Access Compliance Report

Public Rights-of-Way

(Curb Ramps)

Intersection ID: 12435	Main Street: ALLEN_ST	Cross Street: PEGRAM_ST	Location:	N
ADA ID: 37D780FCB48C	Ramp Type: BlendTrans1	Initial Pass/Fail: Fail	Overall Compliance: No	Severity Score: 36.25

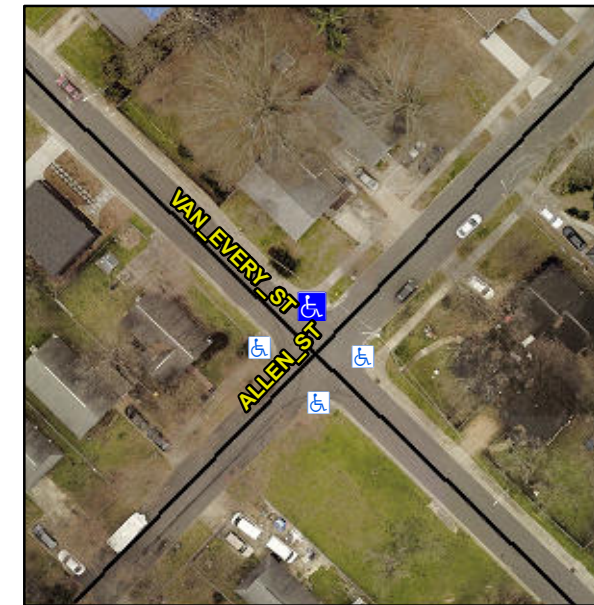
Not Found, R304.5.1, R304.5.3

Compliance	Description	Data	Compliance	Description	Data
N/A	Ramp Length (in)	63.5	Yes	BlendTrans Slope (%)	4.3
No	Ramp Width (in)	29.0	No	BlendTrans XSlope (%)	2.6
N/A	Flare Type LT	N/A	N/A	Flare Type RT	N/A
N/A	Flare Slope LT (%)	N/A	N/A	Flare Slope RT (%)	N/A
N/A	Flare Traversable LT?	N/A	N/A	Flare Traversable RT?	N/A
N/A	Landing Length (in)	N/A	N/A	DWS Provided?	N/A
N/A	Landing Width (in)	N/A	N/A	DWS Contrast?	N/A
N/A	Landing Slope (%)	N/A	N/A	DWS Length (in)	N/A
N/A	Landing X Slope (%)	N/A	N/A	DWS Full Width?	N/A
N/A	Landing Curb? (Y/N)	N/A	N/A	DWS Offset (in)	N/A
N/A	Shared Landing?	N/A			
N/A	Gutter Ponding?	N/A	N/A	Gutter Slope (%)	N/A
N/A	Gutter Lip Ht (in)	N/A	N/A	Gutter X Slope (%)	N/A
N/A	Painted X Walk1?	No	N/A	Painted X Walk2?	No
	X Walk 1 Direction	To SW		X Walk 2 Direction	To SE
	X Walk 1 Width (in)	N/A		X Walk 2 Width (in)	N/A
	X Walk 1 Slope (%)	2.8		X Walk 2 Slope (%)	0.1
	X Walk 1 X Slope (%)	1.5		X Walk 2 X Slope (%)	2.9

N/A	Ramp inside XWalk1?	N/A	N/A	Ramp inside XWalk2?	N/A
	Road Slope (%)	2.8		Clear Space?	N/A
	Road X Slope (%)	1.9	N/A	Clear Space to XWalk (in)	N/A
N/A	Any Obstructions?	N/A	N/A	Storm Grate/Utility Hazard?	N/A
	Obstruction Type			Storm Grate/Utility Type	
		N/A			N/A
			Yes	Surface Condition? (G/P)	Good
			No	Curb Slope (%)	24.0

Remove & Replace Curb Ramp With Two New Directional Ramps or Equivalent.
